COMMUNITY DEVELOPMENT DEPARTMENT REPORT

APPLICANT: Rodney Evans + Partners, LLC

SUBJECT: [H-2024-0059](#)
Latitude Forty Three Subdivision – AZ,
PP

LOCATION: 675, 715 and 955 S. Wells St., in the east
1/2 of Section 17, T.3N., R.1E.

FENCE SCHEDULE

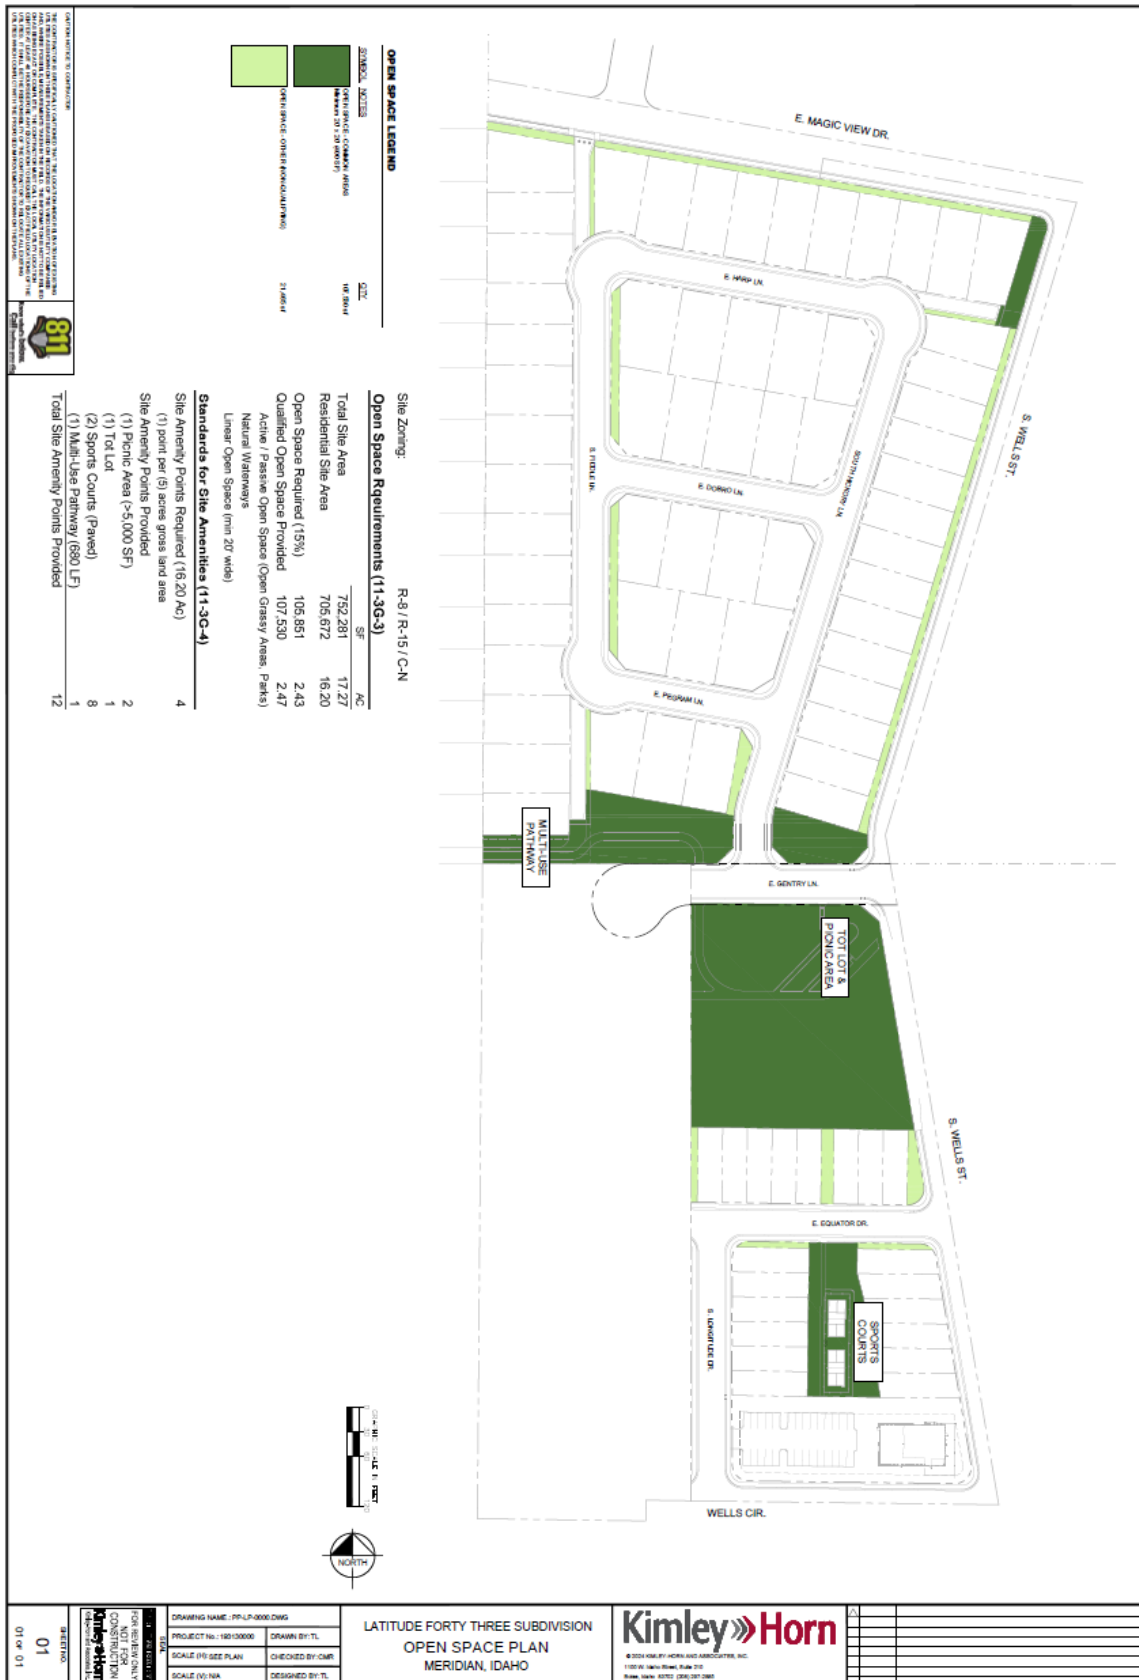
Fencing depicted along S. Hickory St. on Lots 6 and 7, Block 3 and Lots 5 and 6, Block 2 and along E. Magic View Dr. and S. Wells St. is required to be setback a minimum of 10’ from the street side property line per UDC 11-3A-7C.3. The maximum fence height in the required front yard including the front and side yard property lines shall be 3-feet for a closed vision

fence and 4-feet for an open vision fence per UDC 11-3A-7C.2. The fencing plan and landscape plan should be revised accordingly to comply with UDC standards.

- vii. The maximum fence height in the required front yard including the front and side yard property lines shall be 3-feet for a closed vision fence and 4-feet for an open vision fence per UDC 11-3A-7C.2; revise accordingly.

- vi. Fencing along S. Hickory St. on Lots 5 and 6, Block 2 and Lots 6 and 7, Block 3 shall be depicted a minimum of 10-feet from the street side property line per UDC 11-3A-7C.3.
